RECORD DRAWING CERTIFICATION	
ers le,						AS BUILT — CHANGES AS NOTED AS BUILT — NO CHANGES	Dl
Flr.						CONTRACTOR PROJECT COORDINATOR NAME NAME	
	1	12/20/21	JS	DC	ADDENDUM #3	SIGNATURE SIGNATURE	
	REVISION NUMBER	DATE	MADE BY	APP'D BY	REVISION	TITLE DATE TITLE DATE

NEW EQUIPMENT STORAGE BUILDING
RICHARD A. FLYNN, SR. FIRE TRAINING CENTER
VALHALLA CAMPUS, VALHALLA, NEW YORK
GAS AND TELEPHONE LINE PLAN

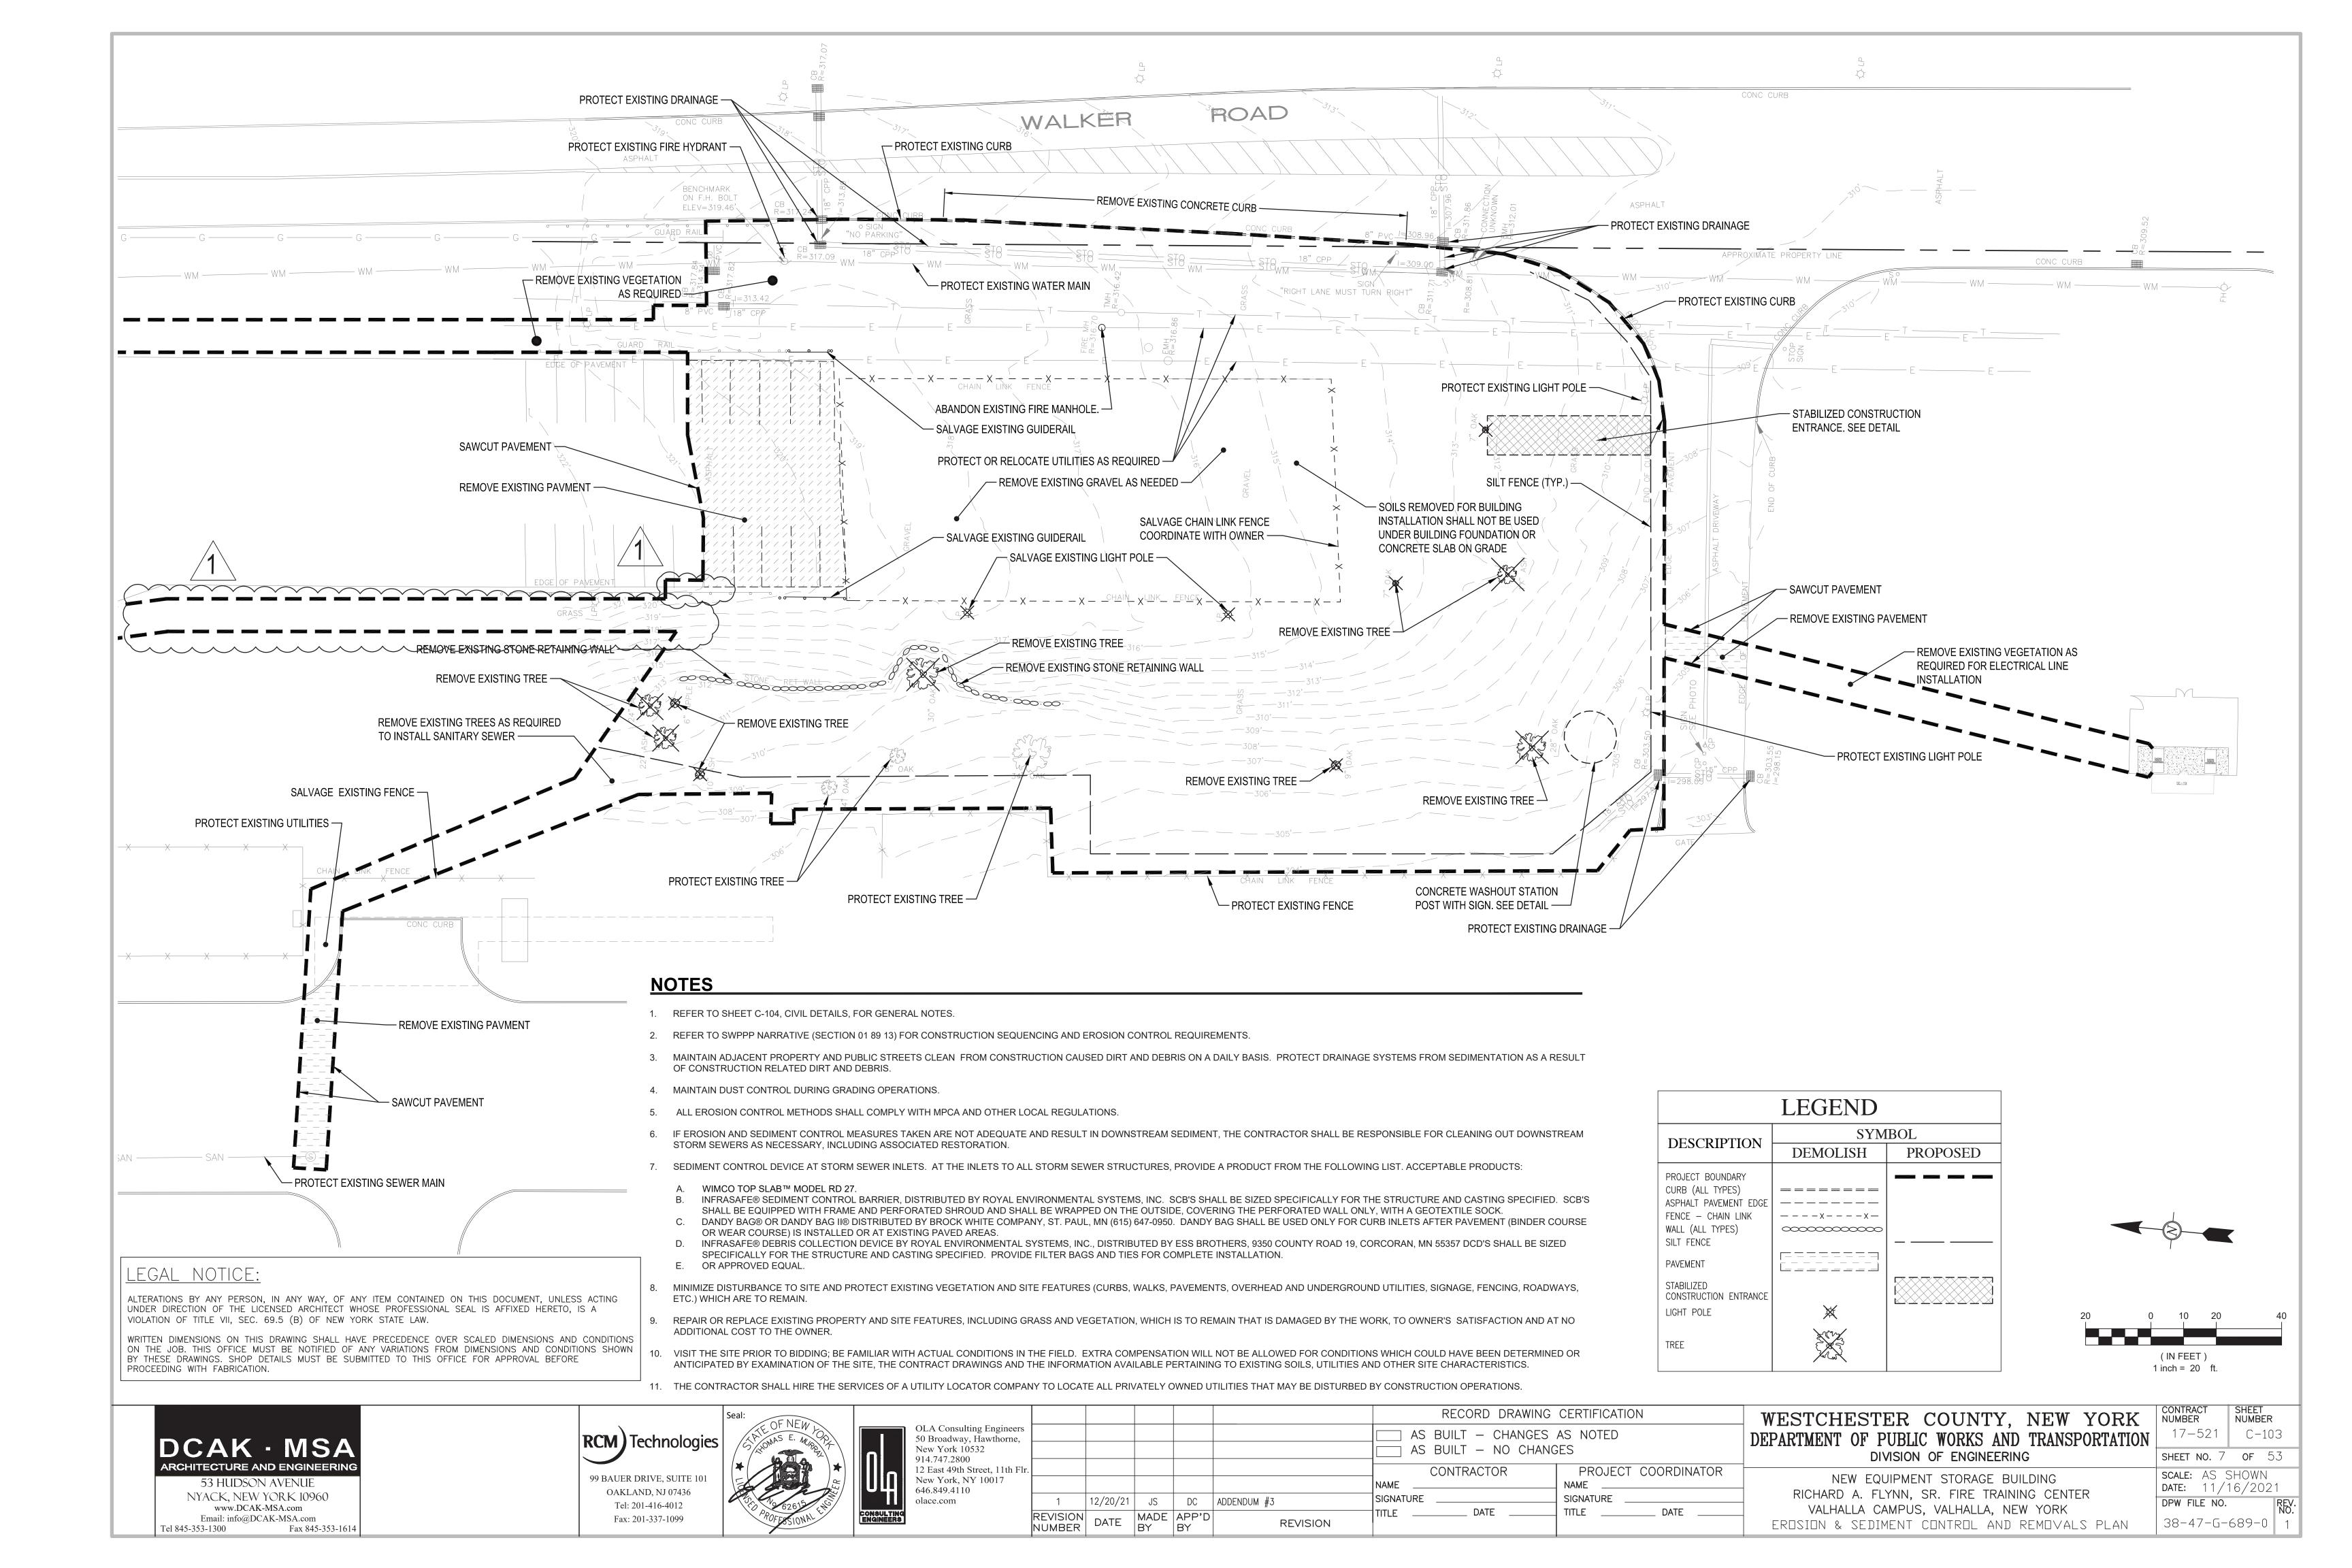
GAS CONNECTION NOTES

- 1. PRIOR TO ANY GAS WORK COMMENCING, FINAL APPROVAL MUST BE OBTAINED FROM WESTCHESTER COUNTY AND CON EDISON TO ALLOW POTENTIAL USE OF THE EXISTING 4" ABANDONED GAS MAIN AS SHOWN ON THE PLANS.

- ONCE APPROVALS ARE OBTAINED FOR THE ABANDONED MAIN, IT SHALL BE THE CONTRACTOR'S RESPONSIBILITY TO PERFORM ANY AND ALL TESTING NECESSARY TO ENSURE THAT THE ABANDONED MAIN COULD BE PUT BACK INTO SERVICE AND HOLD THE NECESSARY PRESSURES TO SERVE THE BUILDING. COSTS ASSOCIATED TO THIS WORK SHALL BE INCLUDED UNDER THE BASE BID.

- 3. PENDING RESULTS OF TESTING, THE CONTRACTOR SHALL THEN PERFORM THE NECESSARY MEASURES TO RECONNECT THE LINE AND MAKE IT OPERATIONAL.
- 4. THE WORK OUTLINED IN THESE NOTES SHALL BE IN LIEU OF THE 4" GAS LINE CONNECTION AT DANA ROAD. THIS WORK IS NOT TO REPLACE ALTERNATE NO. 2. ALTERNATE NO. 2 SHALL BE USED IN THE EVENT THAT THE ABANDONED MAIN CAN NOT BE PLACED BACK INTO SERVICE.
